Addendum No.: 4

Date Of Addendum: 3/1/19

York Correctional Institution Central Plant and Piping Distribution

BI – JA – 465

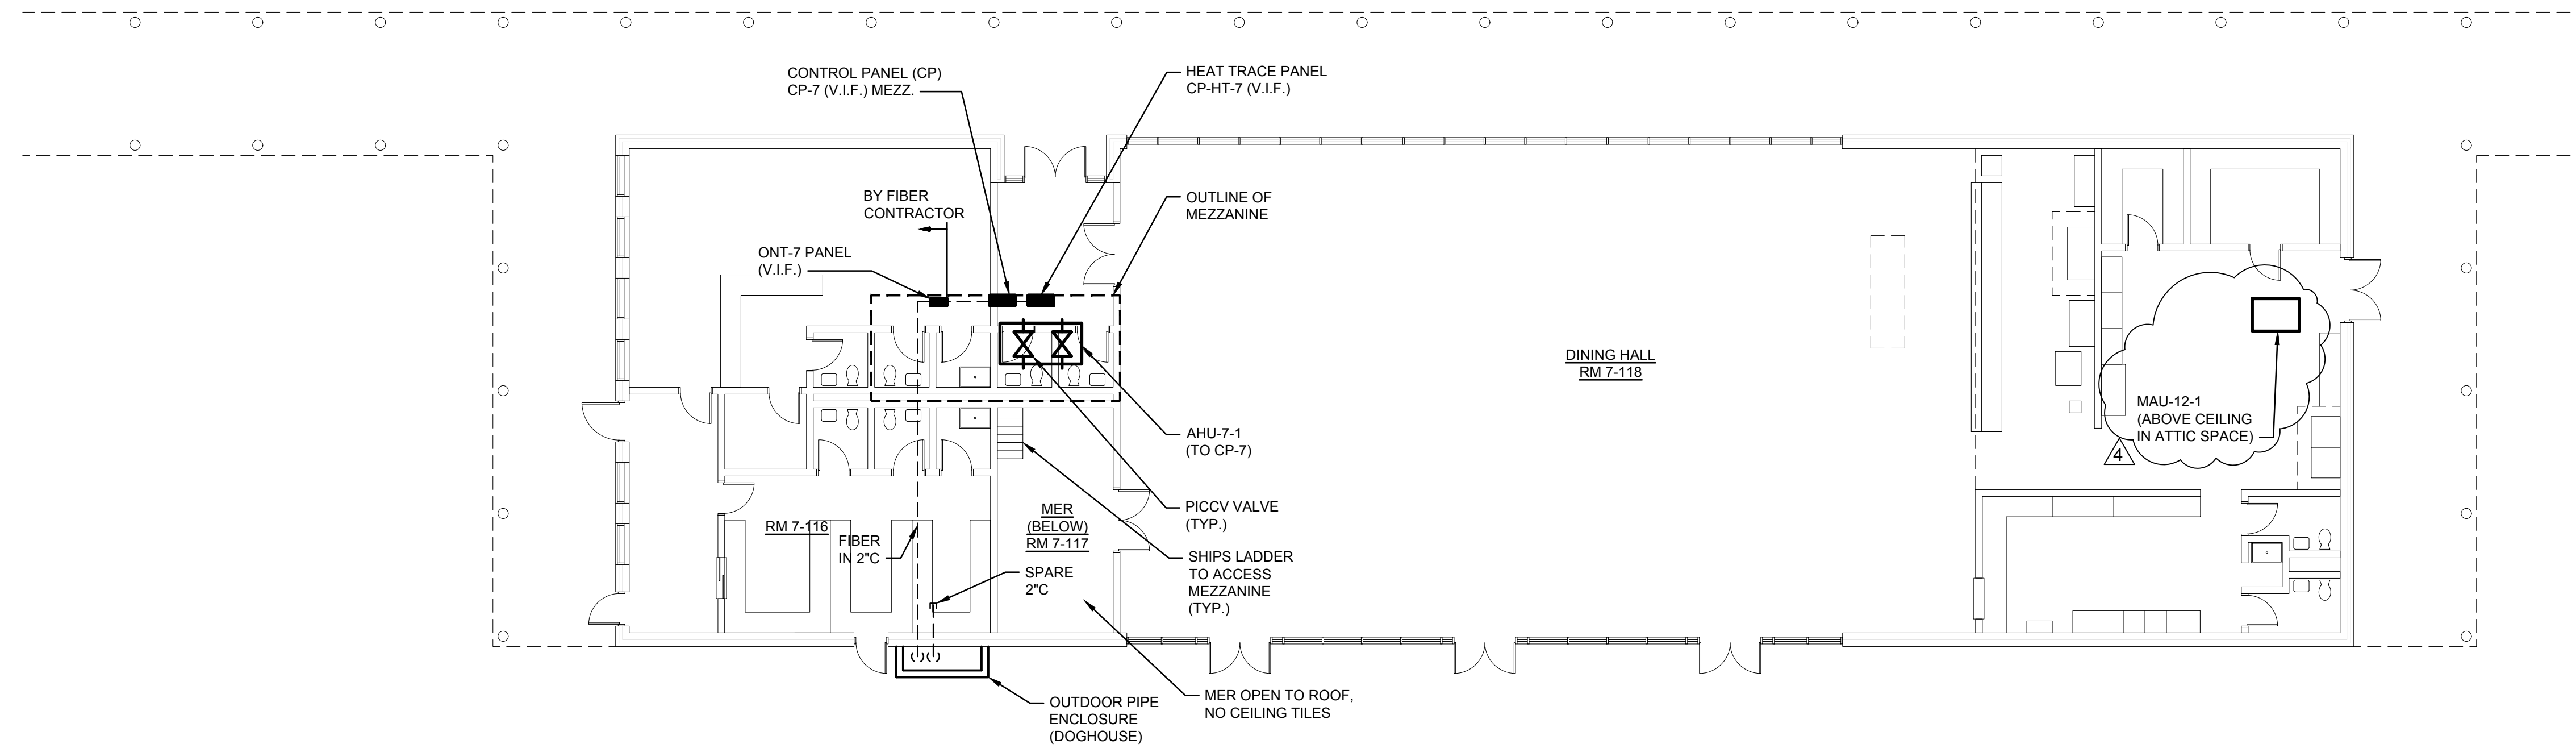
Drawing M757 Building 7 Equipment Layout and Controls

UPDATED drawing to show location of makeup air unit in response to pre-bid question Q127

A127: Refer to contract drawing M766, Addendum 4 for location of MAU-12-1. NOTE; building 7 is similar to building 12. Also, refer to contract drawing M757 for location of MAU-7-1.

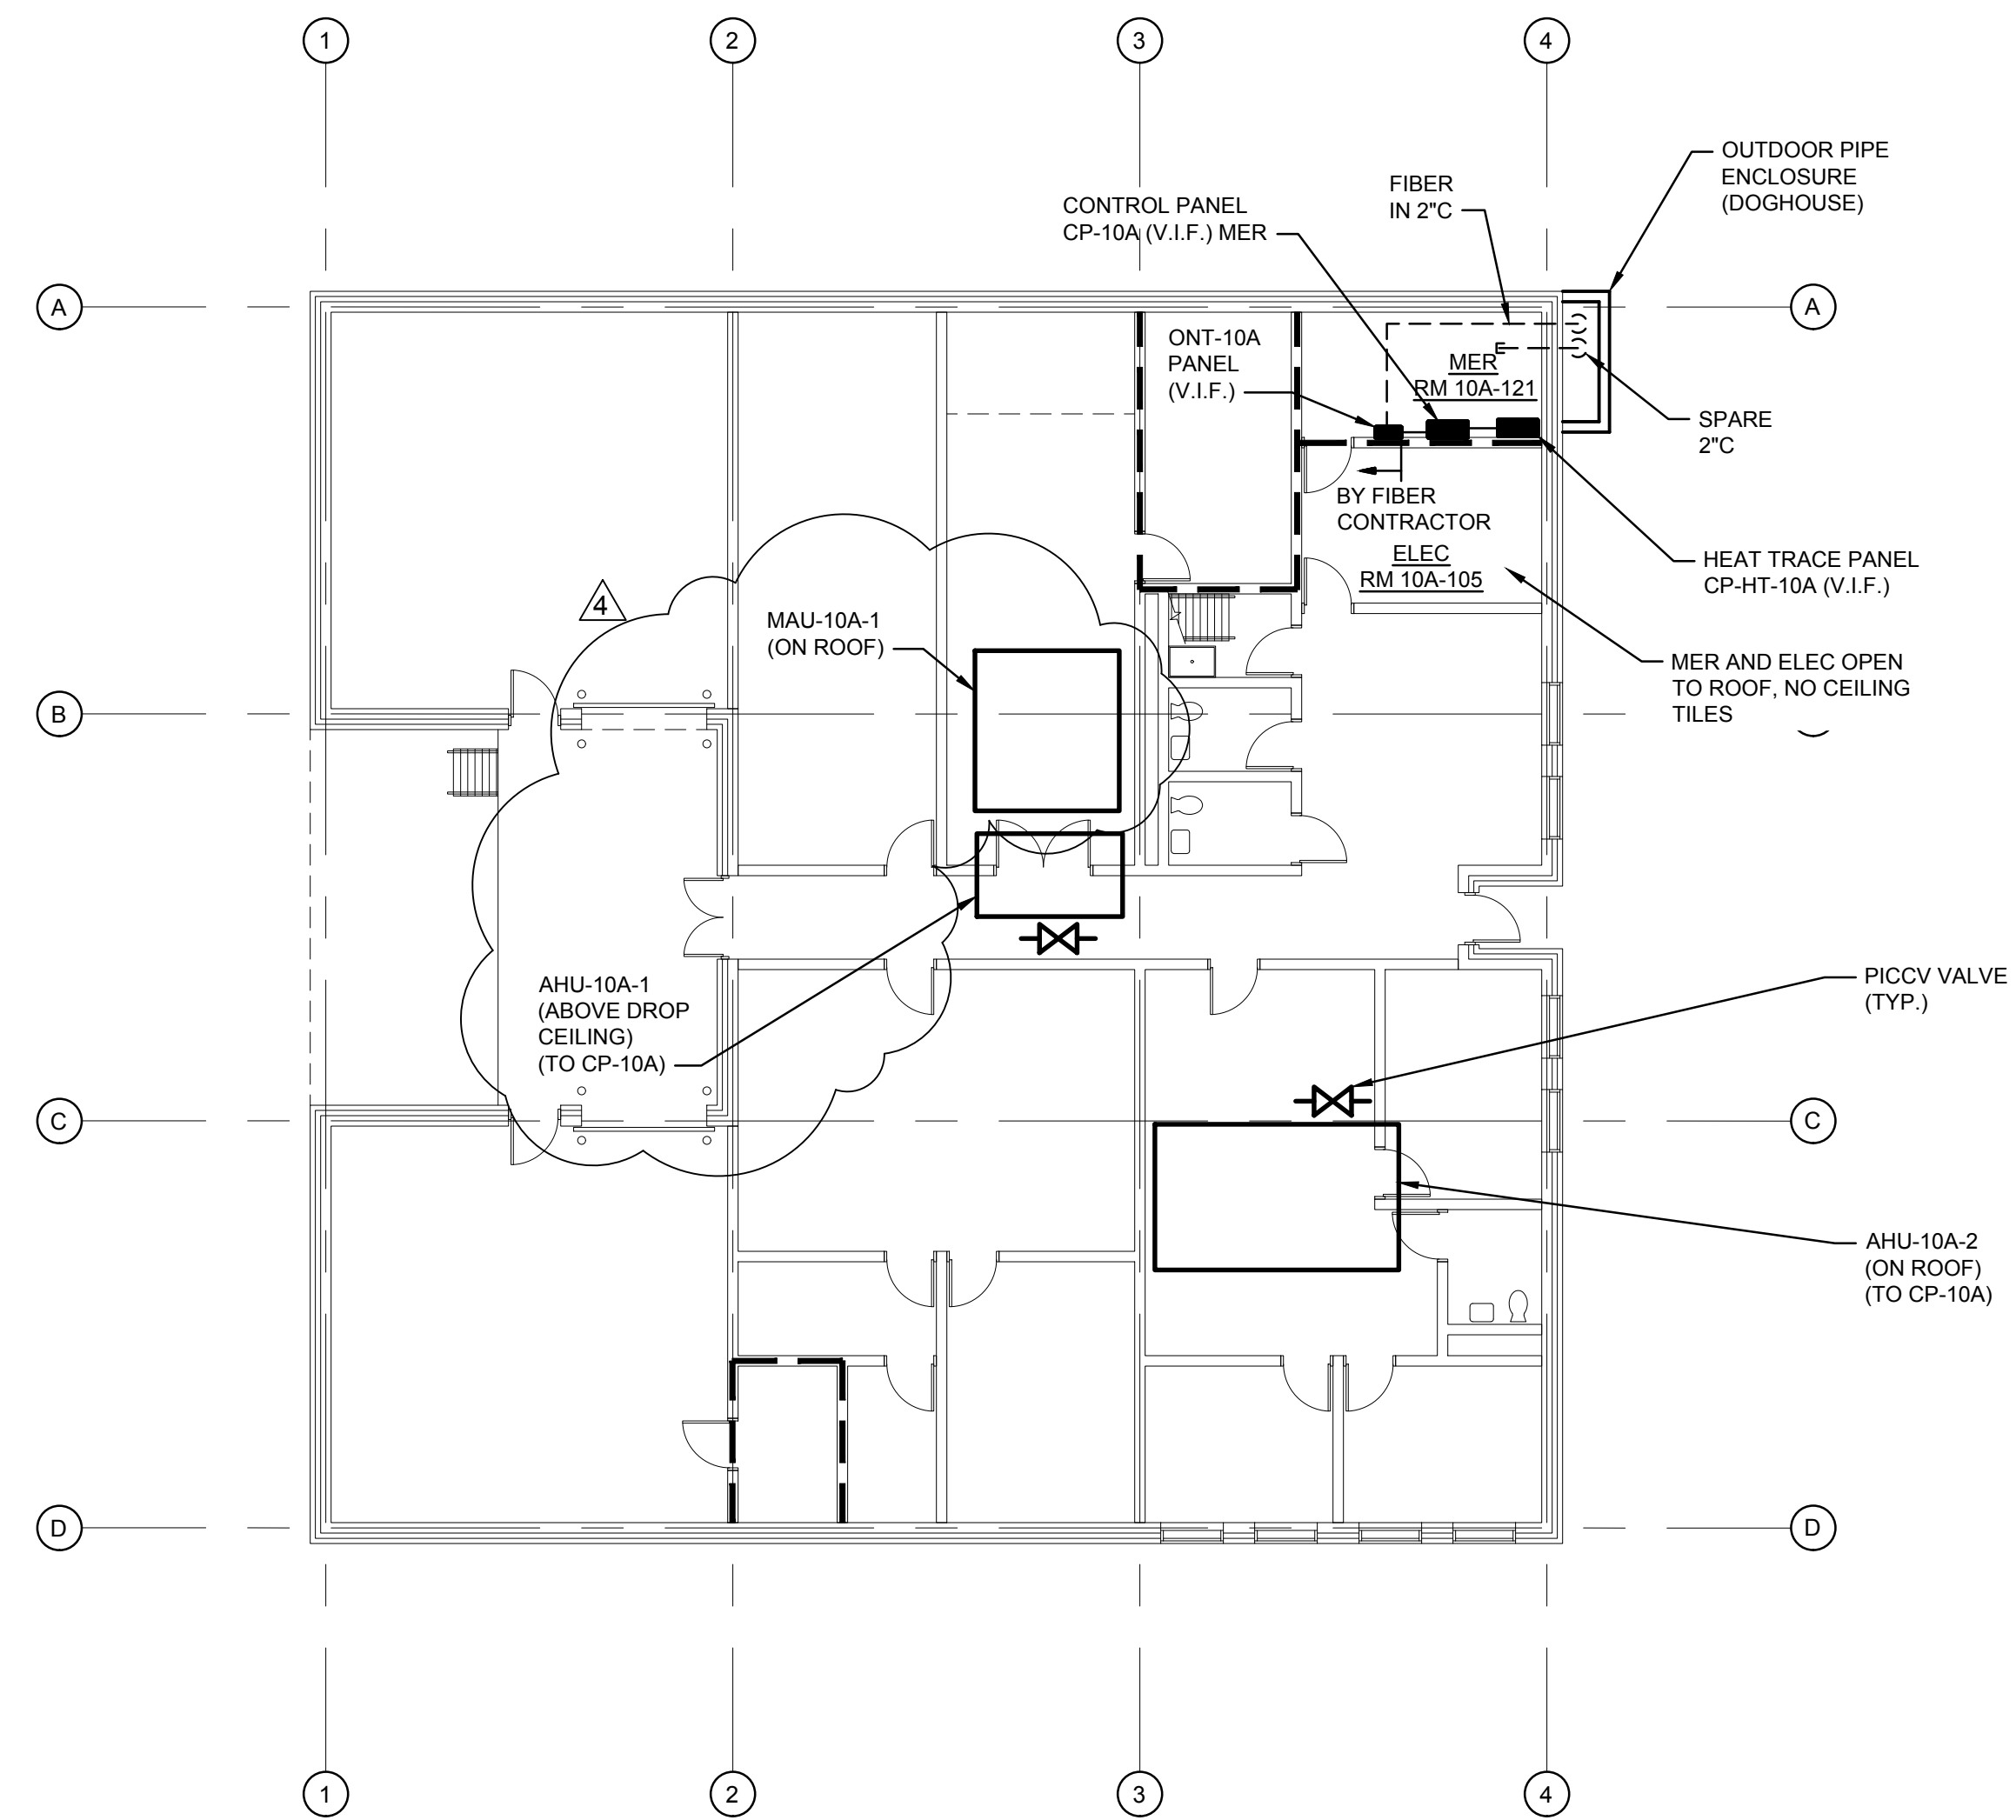
Drawing M764 Building 10A Equipment Layout and Controls

UPDATED drawing to show location of makeup air unit in response to pre-bid question Q126

A126: Refer to contract drawing M764, Addendum 4 for location of MAU-10A-1.

1 BUILDING 12 MEZZANINE INSTALLATION
SCALE: 3/32"=1'-0"

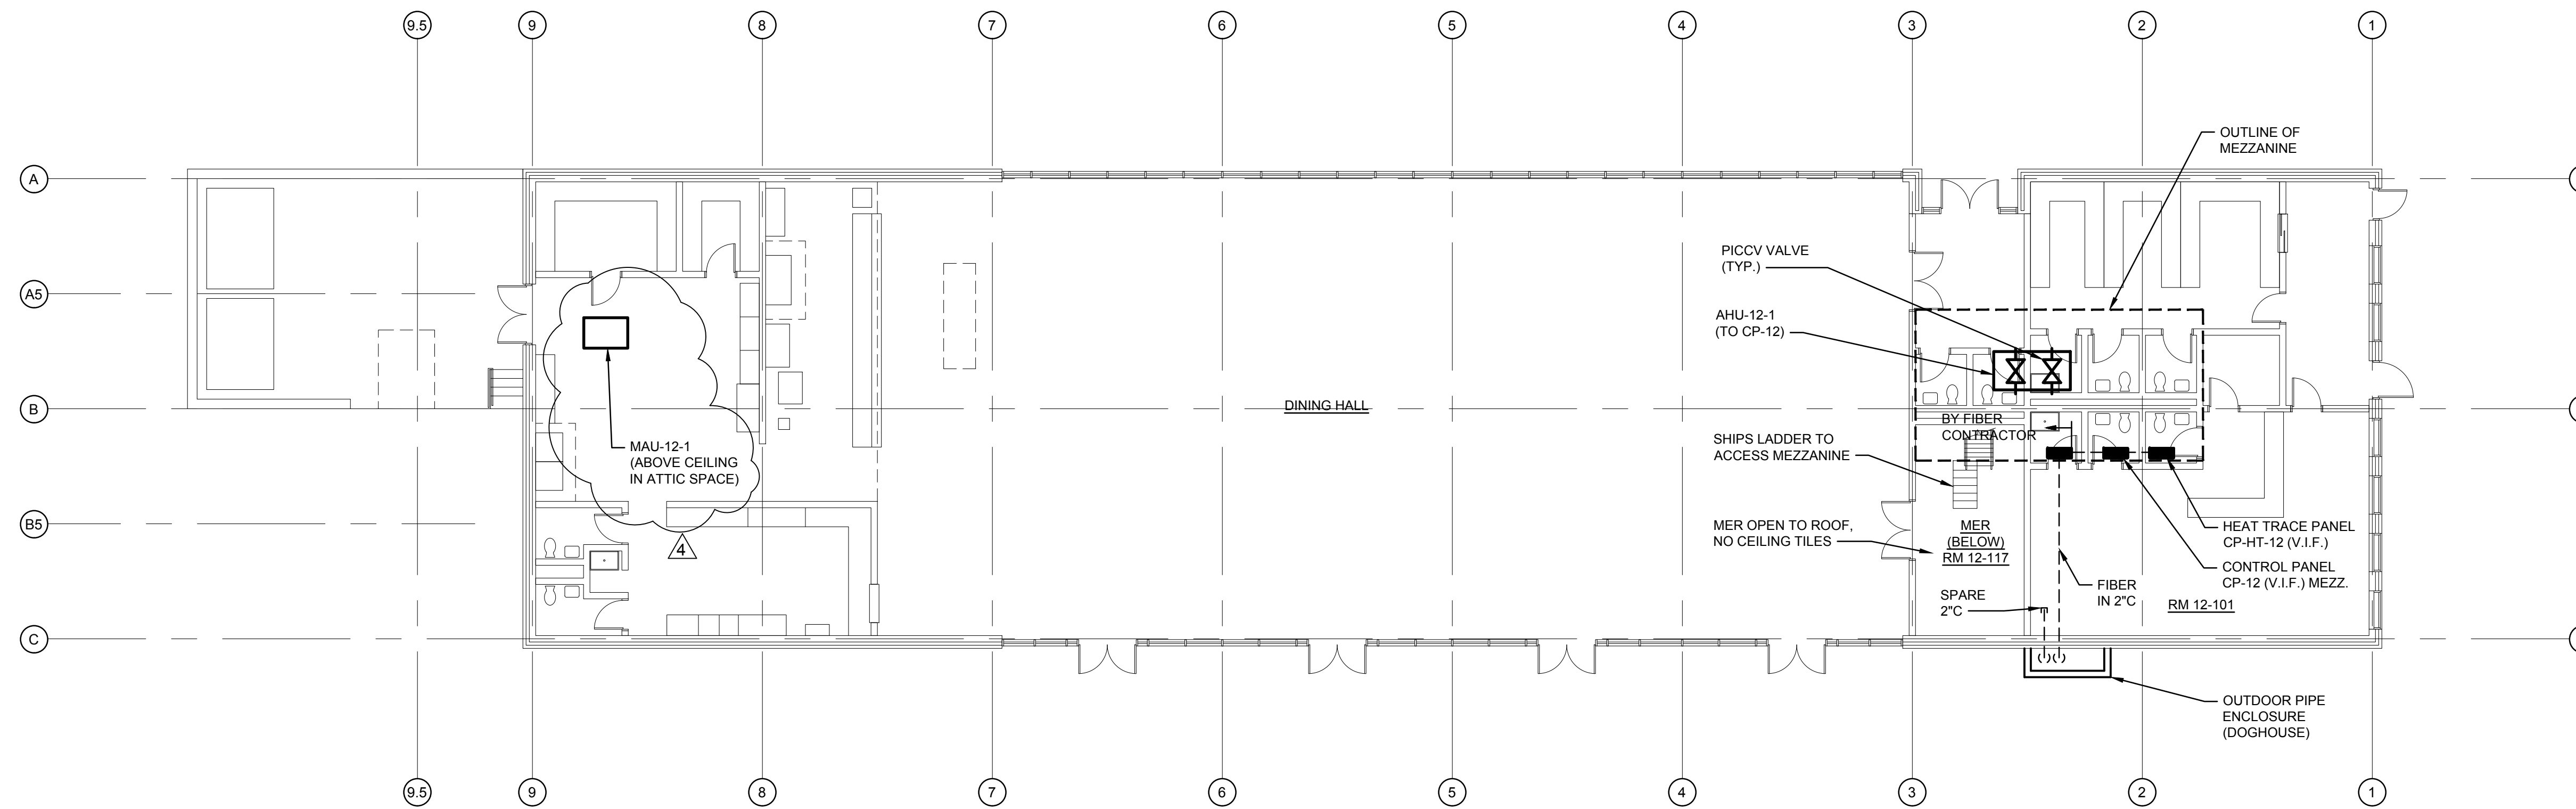
Drawing M766 Building 12 Equipment Layout and Controls

UPDATED drawing to show location of makeup air unit in response to pre-bid question Q127
